## BOLLETTINO TECNICO

N° **139-467**

**TAIL ROTOR DRIVE LINE (TRDL) BEARING SUPPORT BRACKET**

## B.T. 139-467 Rev. A

Figure 1

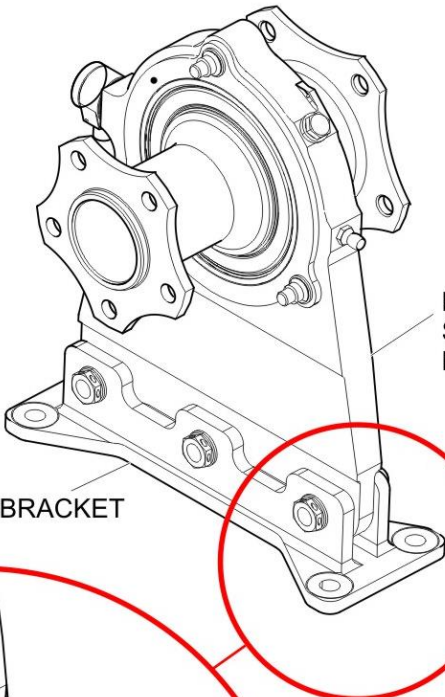
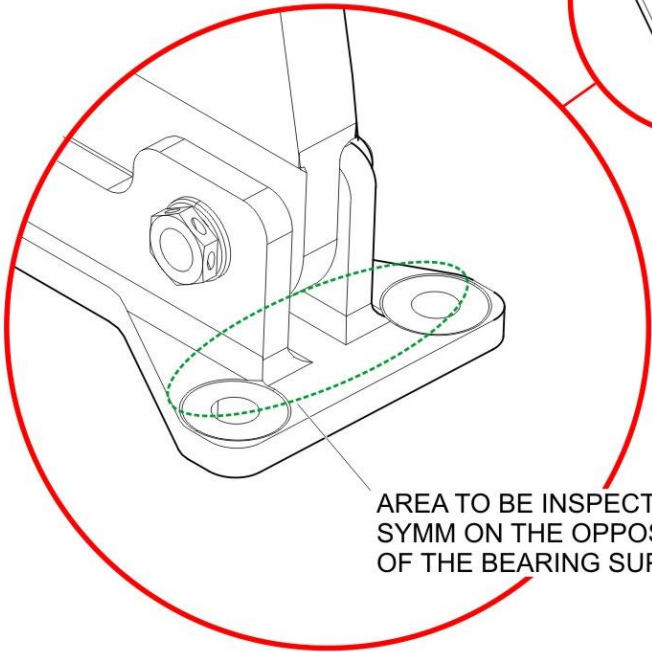
To clean the bearing support bracket to perform the inspection at following step 3.2, refer to figure 1 to identify the areas to be inspected. Remove sealing compound from those areas, if present.

- 3.2 With reference to figure 1, get access to the bearing support area and clean the bearing support bracket from dust, particles and lubricant using a clean, lint-free, cloth (C011) and aliphatic naphta (C059).

- 3.3 Perform the visual inspection for cracks of the bearing support bracket according to figure 1, using a magnifying glass and a strong light.
4. If you do not find any crack, go to step 5, otherwise do as follows:

- 4.1 Replace the bearing support bracket. Refer to AMP DM n° 39-B-65-11-11-

Figure 2

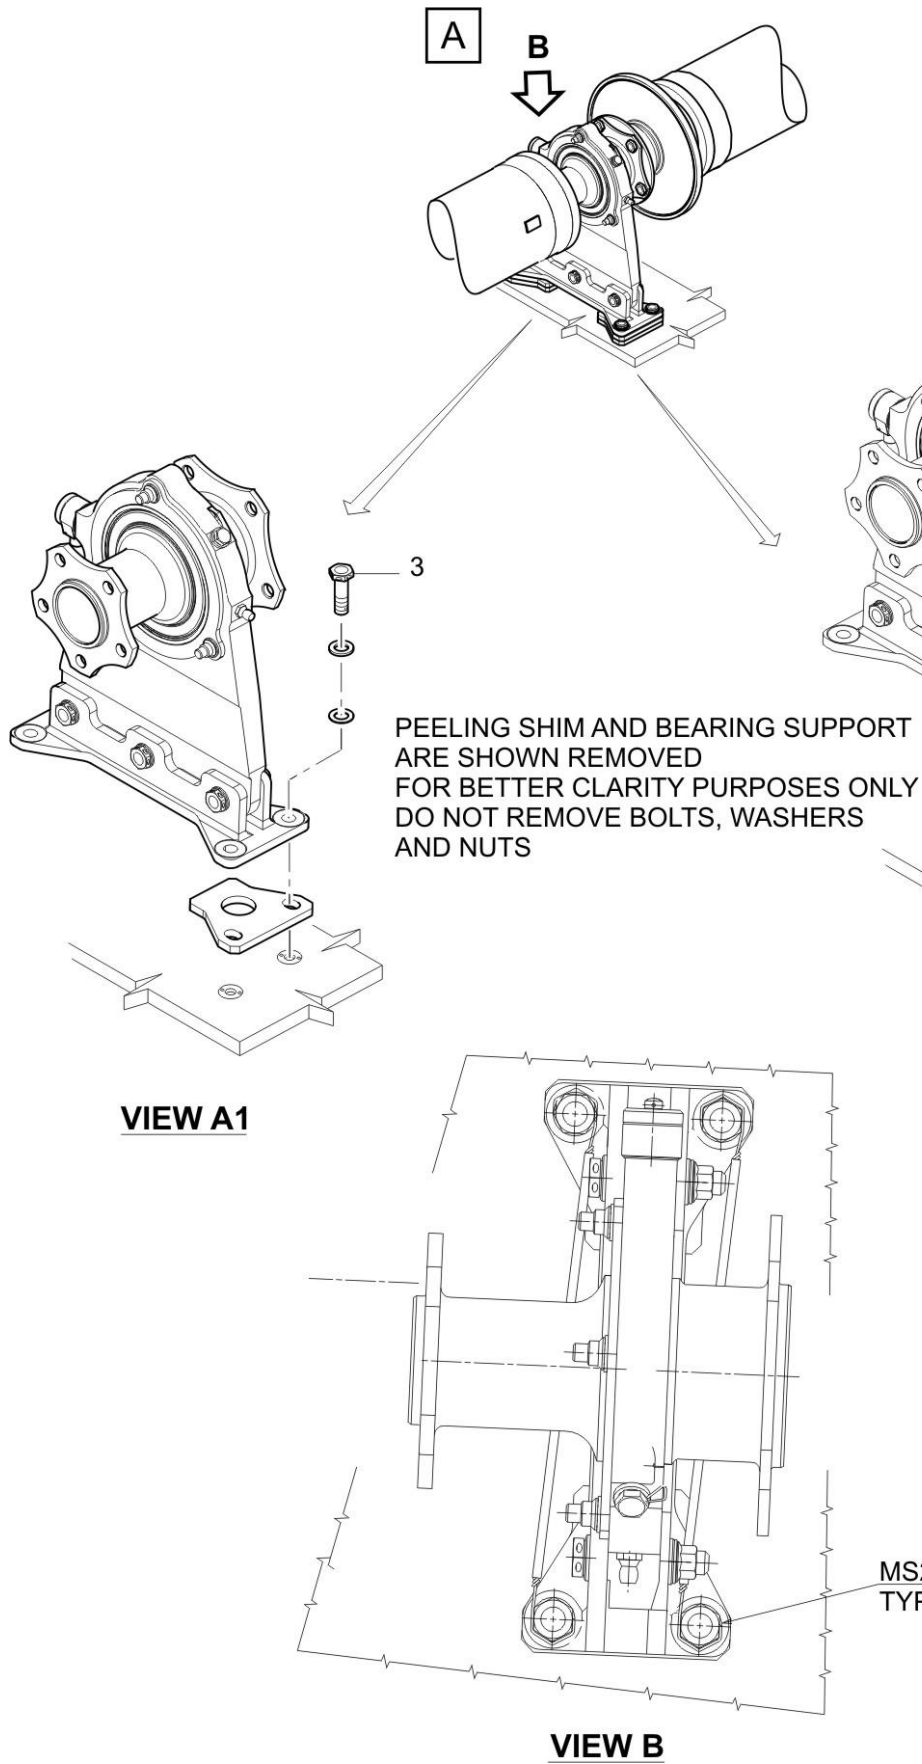
2. With reference to figure 2 view A2, check the torque of the four nuts (1) that fix the bearing support bracket as follows:
  - 2.1 Open access panel 183AL or 184AR and remove access panel 190AL to get access to the work area.

- 3.3 With reference to figure 2 view A1, remove the sealing compound from the bearing support bracket bolts (3) with the plastic scraper.
    - 3.4 Remove the remaining sealing compound using a clean, lint-free, cloth (C011) and solvent (C010).

- 3.8 Safety the four bolts with lockwire P/N MS20995C32 according to figure 2 view B.
  - 3.9 Seal the bolts using Proseal 890A or Proseal 700.
  - 3.10 Apply corrosion protection compound MIL-PRF-16173 grade 1 on the exposed/not sealed parts of the bolt heads and washers where applicable, ensuring to cover their surface completely with an homogenous and gap free layer. Make sure to guarantee 2 mm overlap over the mating surfaces.

- 2.6 Check the torque of the four nuts. Make sure that the torque value is between 6.78 and 9.60 Nm (60.00 thru 85.00 lbf in).
  - 2.7 Report any under-torque / over-torque cases to LHD; contact Product Support Engineering ([CSE.AW139.AW@leonardocompany.com](mailto:CSE.AW139.AW@leonardocompany.com)). Safety the four nuts with four new cotter pins P/N MS24665-136.

- NOTE**
- Record the lockwire installation scheme before performing following step 3.5.
- 3.5 Remove the lockwire from the four bolts (3).
  - 3.6 Check the torque of the four bolts. Make sure that the torque value is between 6.78 and 9.60 Nm (60.00 thru 85.00 lbf in).
